Access Compliance Report

Public Rights-of-Way

Intersection ID: 10025543	Main Street: E_TRADE_ST	Cross Street: N/A	Location: W
ADA ID: DCA0B854A099	Ramp Type: Directional1	Initial Pass/Fail: Pass	Overall Compliance: No
Severity Score: 0.25			
Codes/Mitigation Info/Possible Solution		Field Measurements/Component Compliance

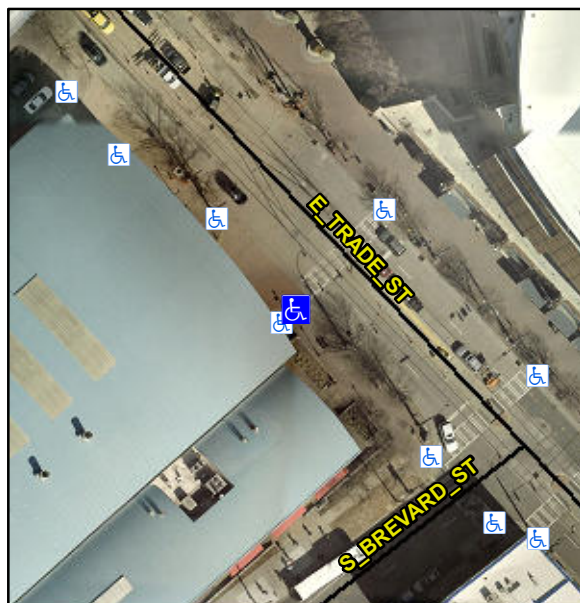
R304.5.3, R304.5.2

Compliance	Description	Data	Compliance	Description	Data
N/A	Ramp Length (in)	76.0	No	Grade Break?	No
Yes	Ramp Width (in)	59.0	N/A	Grade Break Slope (%)	N/A
Yes	Ramp Slope (%)	6.0	N/A	Grade Break XSlope (%)	N/A
No	Ramp XSlope (%)	2.9			
N/A	Flare Type LT	N/A	N/A	Flare Type RT	N/A
N/A	Flare Slope LT (%)	N/A	N/A	Flare Slope RT (%)	N/A
N/A	Flare Traversable LT?	N/A	N/A	Flare Traversable RT?	N/A
Yes	Landing Length (in)	48.0	Yes	DWS Provided?	Yes
Yes	Landing Width (in)	48.0	Yes	DWS Contrast?	Yes
Yes	Landing Slope (%)	0.2	Yes	DWS Length (in)	24.0
No	Landing X Slope (%)	5.2	Yes	DWS Full Width?	Yes
N/A	Landing Curb? (Y/N)	N/A	Yes	DWS Offset LT (in)	6.0
N/A	Shared Landing?	No	Yes	DWS Offset RT (in)	1.0
Yes	Gutter Ponding?	No	Yes	Gutter Slope (%)	2.1
Yes	Gutter Lip Ht (in)	0.0	No	Gutter X Slope (%)	3.5
N/A	Painted X Walk1?	Yes		Road Slope (%)	2.0
	X Walk 1 Direction	To NE		Road X Slope (%)	1.4
	X Walk 1 Width (in)	113.0		Clear Space?	Yes

**Remove & Replace Entire Ramp.
Remove & Replace Gutter.**
